Rebuttal Proof of Evidence on Noise

Prepared by Rhys Scrivener of KR Associates (UK) Ltd
for Reading Borough Council

PROPOSED RESIDENTIAL DEVELOPMENT
55 VASTERN ROAD, READING

15th October 2021

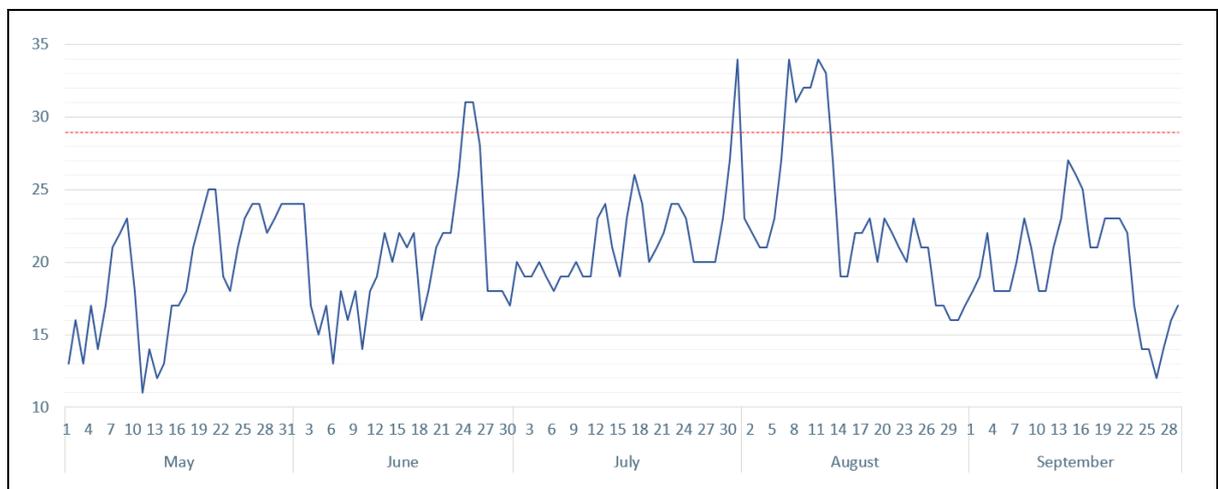
2.17 The following graph shows the maximum daily ambient temperature at the Reading site between 1st May 2021 and the 30th September 2021. It can be clearly seen that the ambient temperature does not exceed 29°C.

2.18 Mr Peckham explains in his PoE at section 2.7 that the transformer fans only operated between 1st May 2021 and 20th September 2021 for two periods at the end of June 2021 and that the fans did not operate in the hot temperatures recorded during July. Mr Peckham has not provided any evidence of what will happen when the ambient temperature exceeds 29°C as SSE have confirmed that the fans are more likely to run when the ambient temperature is higher.

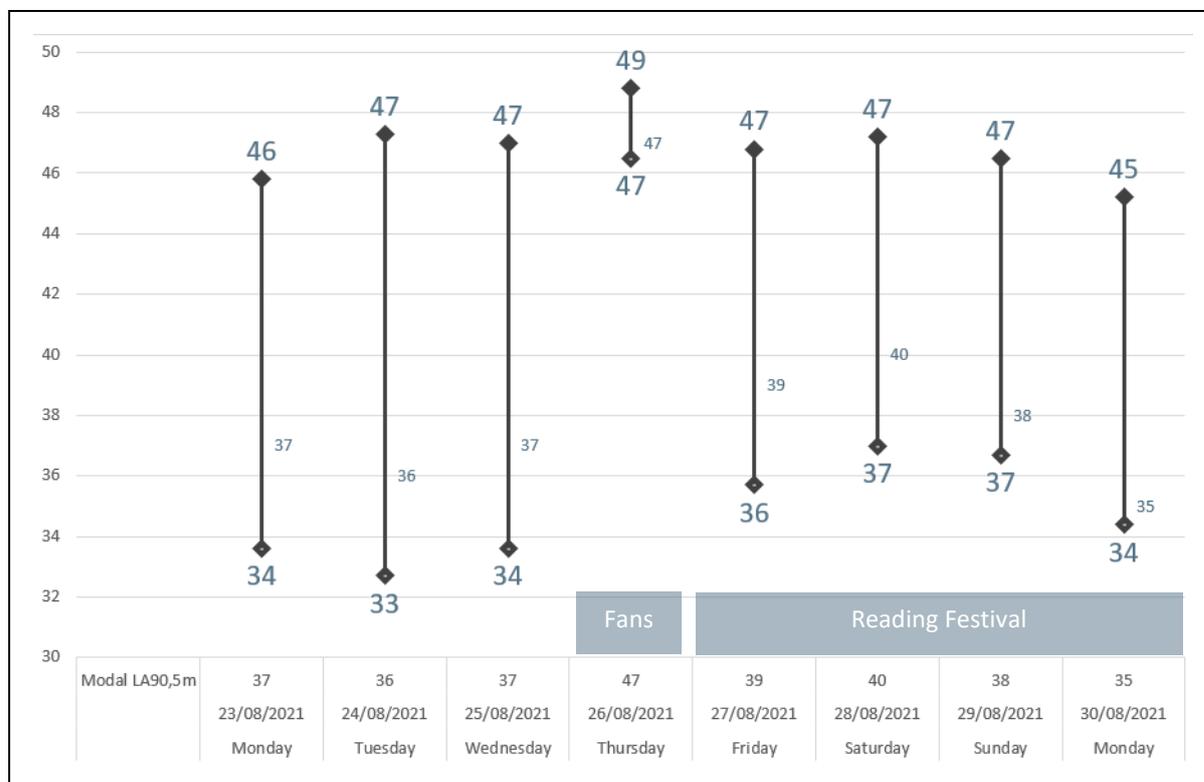
2.25 I have therefore used the raw data supplied by Mr Peckham to produce a graph of the 5-minute background noise levels. The graph shows the minimum, maximum and modal LA90, 5-minute background noise levels for each evening period. This highlights the issue of the

period between 23:00 on Thursday 26th August 2021 and 07:00 on Friday 27th August 2021 and the night times levels between 23:00 and 07:00 over Friday, Saturday, and Sunday night.

2.26 Mr Peckham has provided no explanation of the anomaly within his PoE. I have checked the weather for the period and there are no indications that the wind speed, precipitation, or other weather anomaly could have caused these elevated levels.

3D Noise Map of SSE Transformer Fans

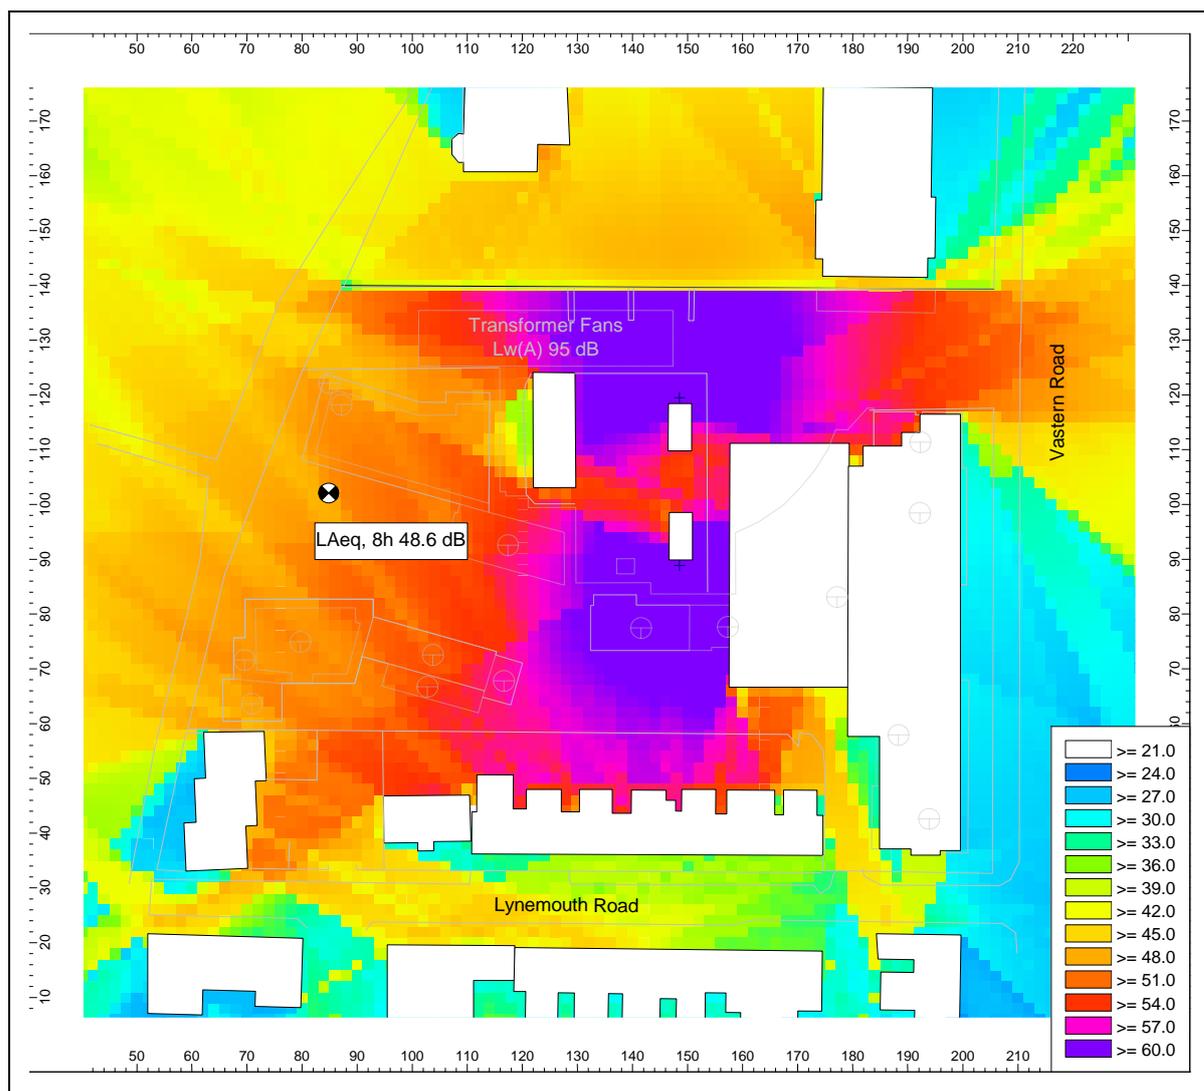
2.33 I have re-run the 3D noise map with the existing buildings in place and a measurement position at the same position as Mr Peckham’s measurements between Monday 23rd August 2021 and Monday 30th August 2021 with the SSE transformer fans running. The results of my 3D noise map indicate that if the SSE transformer fans were both running, they would have produced an 8-hour L_{Aeq} of 48.6 dB.

2.34 I am of the professional opinion that on the balance of probabilities that the fans associated with the SSE Transformer were running for much of the period between 23:00 on Thursday 26th August 2021 and 07:00 on Friday 27th August 2021 as they are very similar to the levels that the above 3D noise map calculated.
